SUBJECT: Requests a two year delay in approval of license amendment for Homestake Mining Company Uranium Mill, SUA-1471, Milan, New Mexico

**Re: Homestake Mining Company Uranium Mill,
License No. SUA-1471, Docket No. 40-8903**

**TECHNICAL MEMORANDUM IN SUPPORT OF MASE LETTER TO NUCLEAR
REGULATORY COMMISSION REQUESTING TWO-YEAR DELAY IN APPROVAL
OF LICENSE AMENDMENT FOR HOMESTAKE MINING COMPANY URANIUM
MILL, SUA-1471, MILAN, NEW MEXICO**

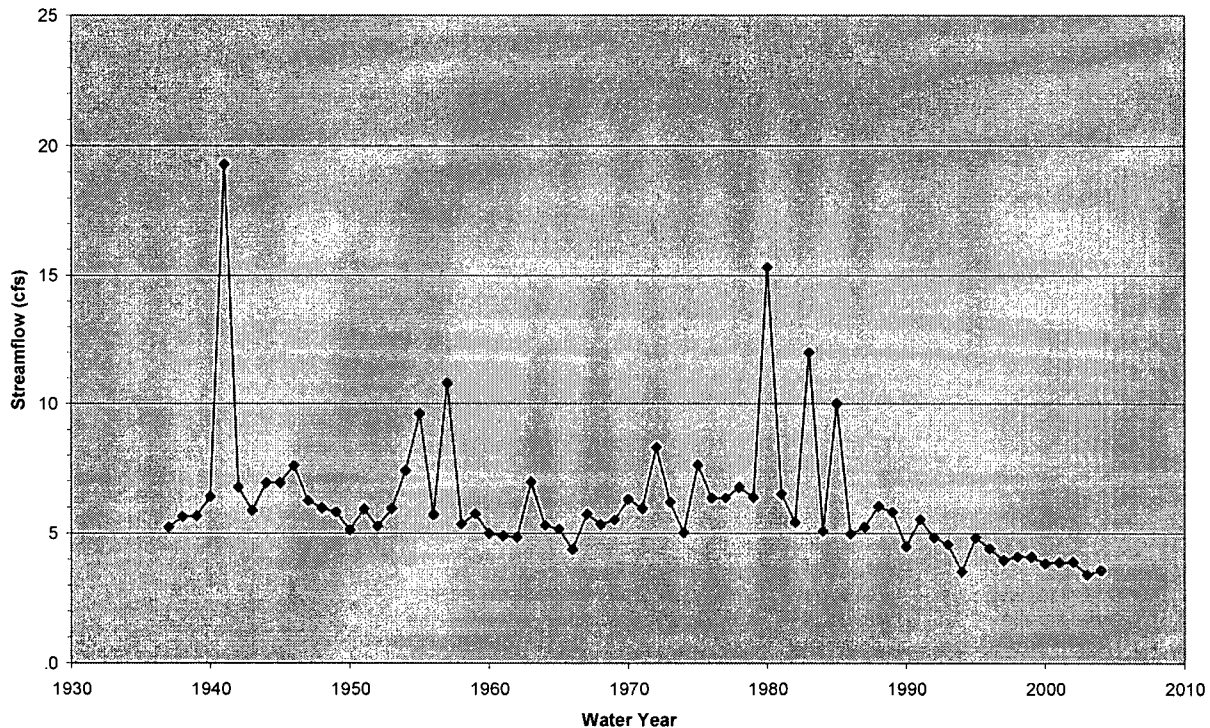
- We calculate that an evaporation pond at least *five times* the size of the proposed EP-3 is needed to treat the 1.15 million gallons per day of contaminated groundwater being pumped from the alluvial and bedrock aquifer down-gradient of the Homestake tailings. A pond or series of ponds even larger than 150 acres may be needed if the flow rates for the injection-pumpback system are increased. Furthermore, the location of a properly sized new evaporation pond should not be over the San Mateo Creek alluvium, as is now proposed for EP-3, even with liners and leak detection systems.
